TECHNICAL BULLETIN

LTB00585
22 AUG 2013

Difficulty In Selecting Gears/Poor Gear Shift Quality

Defender (LD)

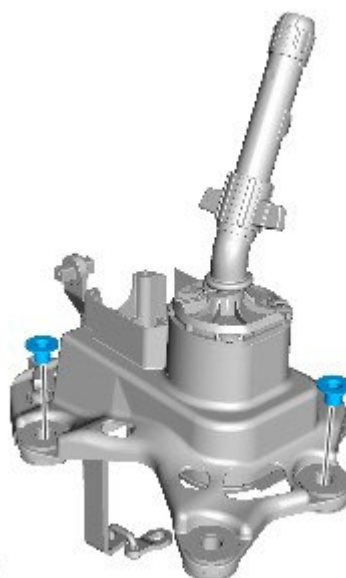
- 3.** Remove 2 of the securing bolts from the positions shown in the illustration (E158687) opposing corners.

1. Insert the two spacer bushes as shown in illustration (E158687).

2. Tighten the securing bolts to 25Nm.
